U.S. Department
of Transportation

Carquinez Strait, (7.1)
16590
Ser: 376
July 17, 2001

BRIDGE PERMIT

PROPOSED BENICIA-MARTINEZ BRIDGE
 OVER CARQUINEZ STRAIT
 Milepost 7.1 (Km 11.4)
 CONTRA COSTA & SOLANO COUNTIES, CALIFORNIA
 CALIFORNIA DEPARTMENT OF TRANSPORTATION
 SHEET 1 OF 3 MARCH 2001

PROPOSED BRIDGE NAVIGATION CHANNEL CLEARANCES

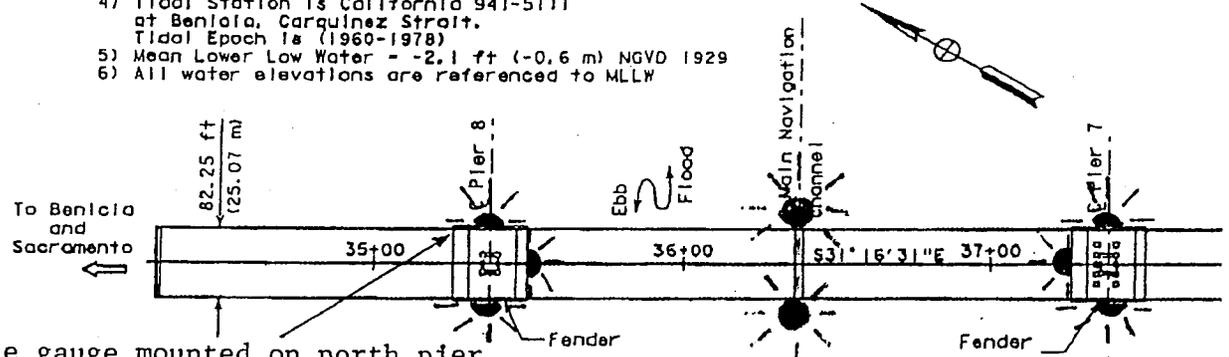
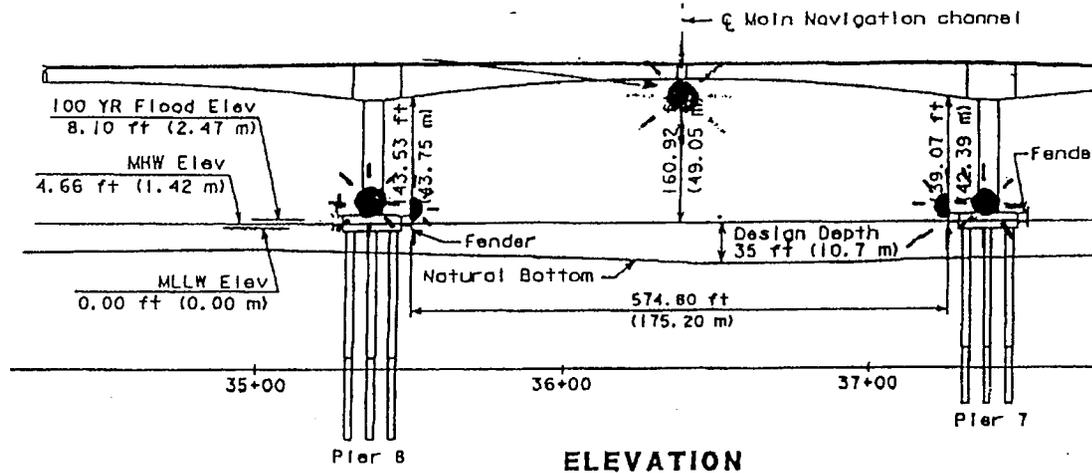
Clearance gauge mounted on north pier facing upstream
 Series E Gauge
 36 inch numerals spaced every 10 feet

Navigational Lights and/or Other Signals, approved as shown, pursuant to 33 CFR 118.

PROPOSED BRIDGE NAVIGATION CHANNEL CLEARANCES

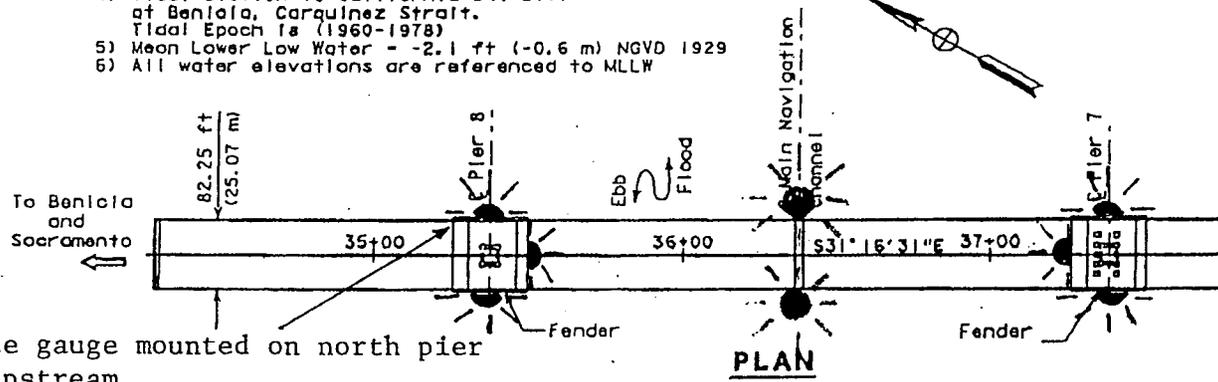
Clearance gauge mounted on north pier facing upstream
 Series E Gauge
 36 inch numerals spaced every 10 feet

Navigation Lights and/or Other Signals, approved as shown, pursuant to 33 CFR 118.
